**Re: British Columbia Transmission Corporation (BCTC)  
Project No. 3698486 – Interior to Lower Mainland Transmission Project  
Errata Sheet for Exhibit B-1**

**Errata Sheet for Exhibit B-1 – ILM Project CPCN Application and Appendices**

4 **Figure 4-1. ILM Nomograms**

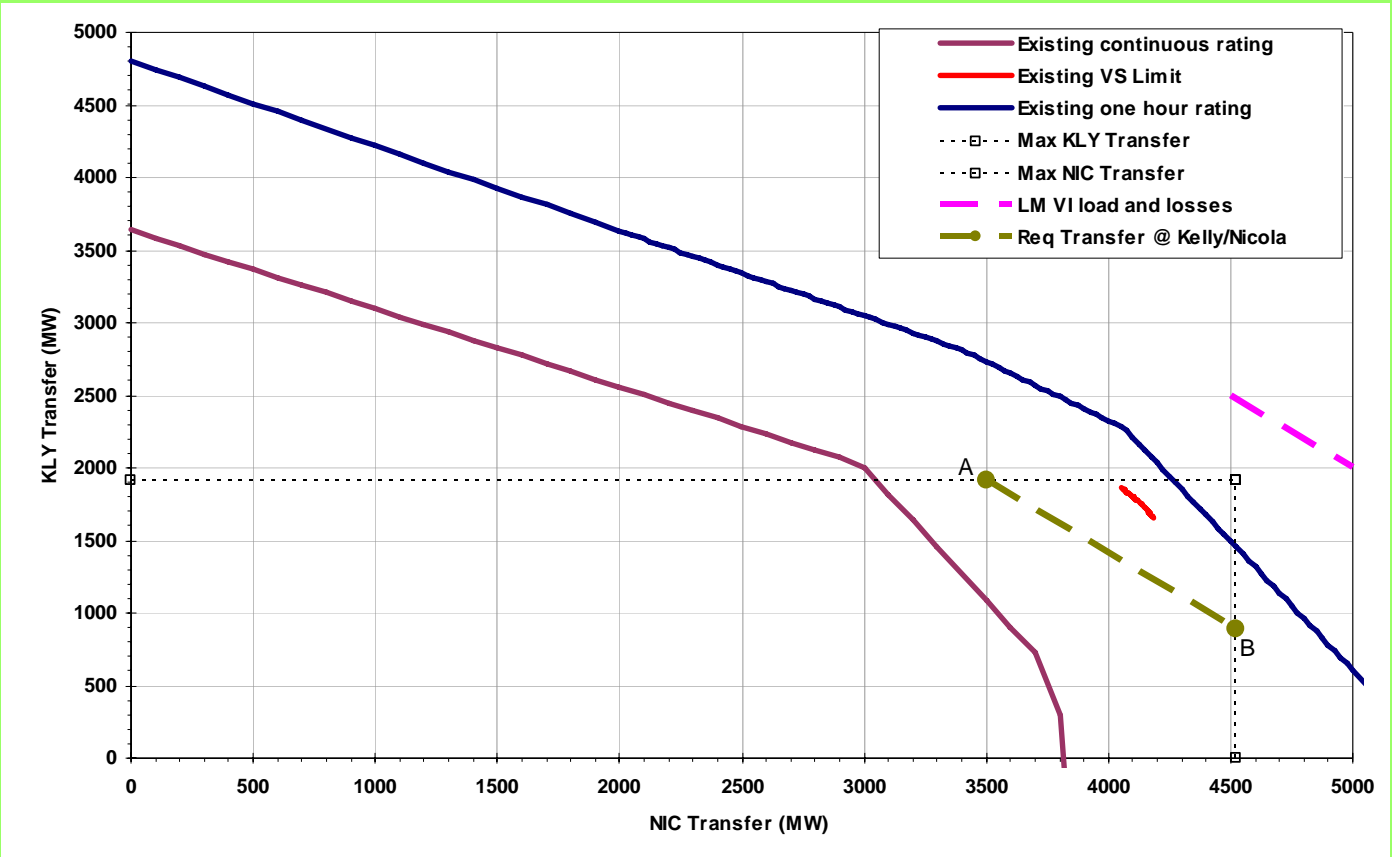
5. Section 4.1 – page 10
  - a. Replace Figure 4-1 to add letters “A” and “B” to the “Req Transfer @ Kelly/Nicola” line
6. Section 5.1 – page 12
  - a. Line 5 to 6 – Delete “from incremental load growth minus the net increase in Coastal Generation of about 200 MW for a total 20-year incremental CU of 1400 MW”

**Figure 5-2. Total Generation and Load in LM and VI – 2006 Contingency Resource Plan 1**

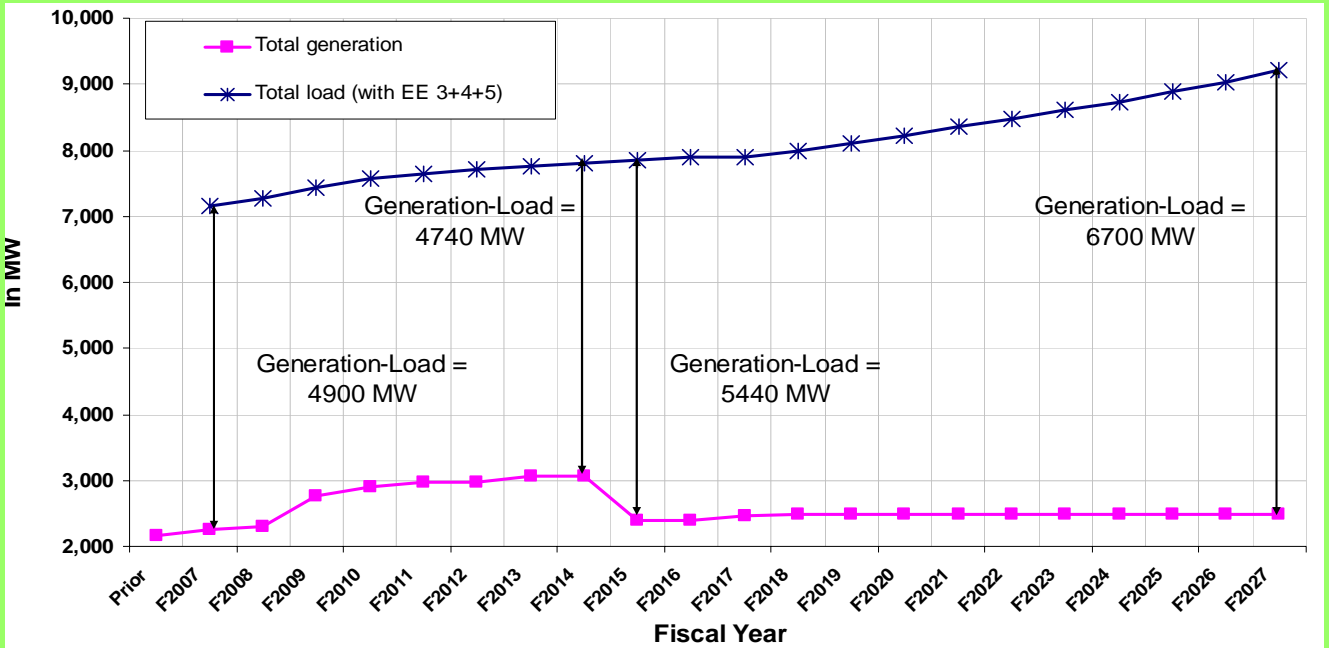
- b. Line 6 – Replace “1600 MW and 2000 MW” with “1800 MW and 2200 MW”
7. Section 5.1 – page 13
  - a. Replace Figures 5-2 and 5-3 to show additional detail

**Figure 5-6. Total Generation Additions and Load Growth in Interior Regions – 2006 Contingency Resource Plan 2**

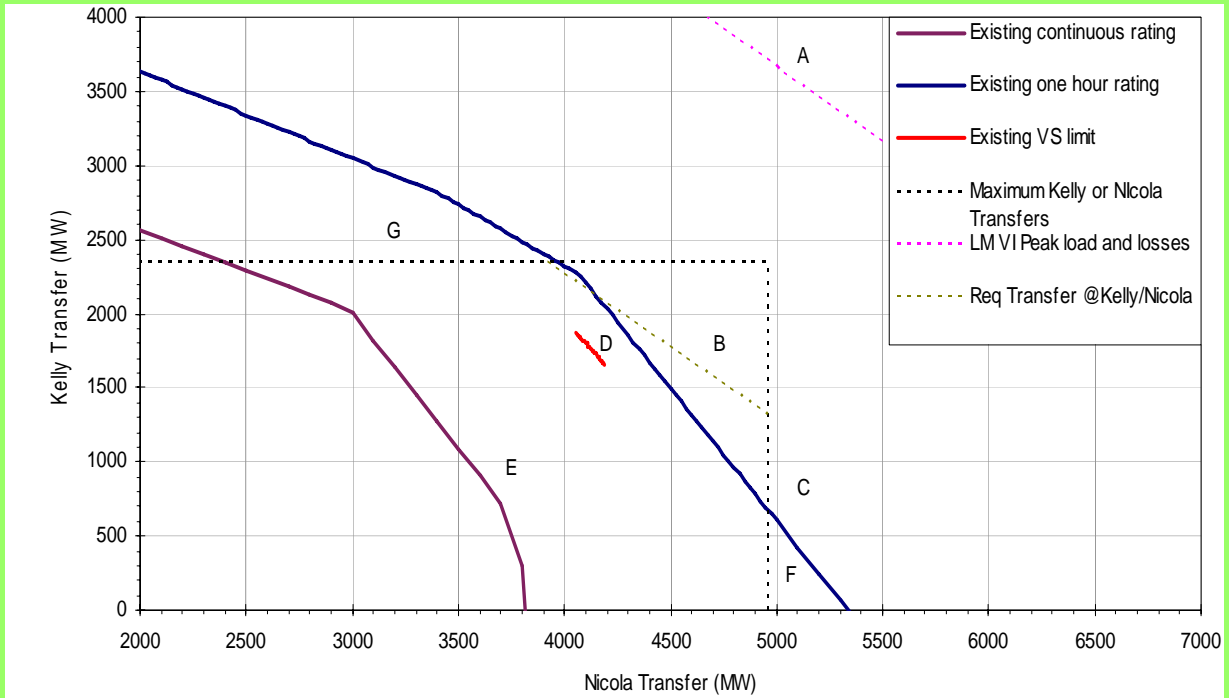
9. Section 5.1 – page 15
  - a. Replace Figure 5-6 to add missing detail
10. Section 5.2.2.1 – page 20
  - a. Line 6 – Replace “(line C)” with “(line E)”
